The PKOLS-Mount Douglas Conservancy wants to bring to Council's attention the Saanich document [Mount Douglas Communications Facility, Guiding Principles for Development and Operations](#).

The [Mount Douglas Communications Facility, Guiding Principles for Development and Operations](#) was established in conjunction with our Society in 2015 by the then Director of Legislative Services. It follows principles expressed by Council from when the site was first constructed.

Summit Parking lot tower location

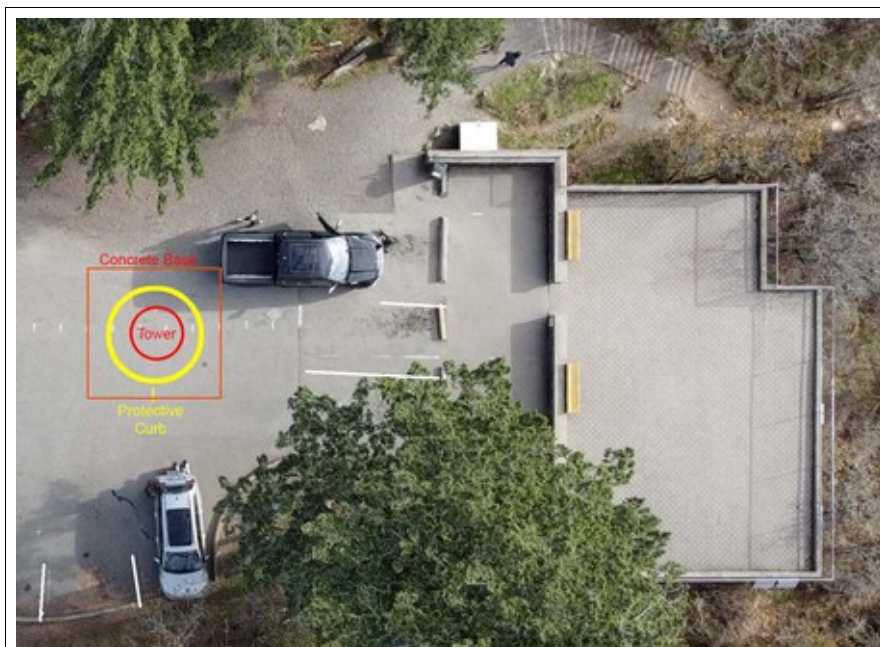
- **At this point, the tower specifications should have been changed to allow a summit installation,** but instead the tower location was changed to the parking lot, ignoring the natural park setting.

As it now stands, unless Council intervenes, the replacement tower

- Will be 40m tall instead of 30m., doubling the tower price and weight.
- Will be located in the south-centre of the summit parking lot, eliminating several of the few summit parking lot spaces, impedes vehicle turnaround space.
- Will exceed the P-9 zone tower height restrictions. It's disappointing that there is the assumption they will simply go to Council for zone height exemption.
- Will be an eyesore from all Saanich, but especially destroying the iconic view as one approaches via Churchill Drive.
- Will require surrounding concrete barriers for protection from cars, further limiting parking and hindering turnaround space.
- Will be a graffiti magnet, a climbing challenge. Hopefully no surrounding chainlink fence!

**The PKOLS-Mount Douglas Conservancy requests Council intervene and direct staff to take steps that will result in this replacement tower constructed “as close to the existing tower as possible, no further than 6m or 20ft [from] the existing tower” as originally specified in the RFP.**
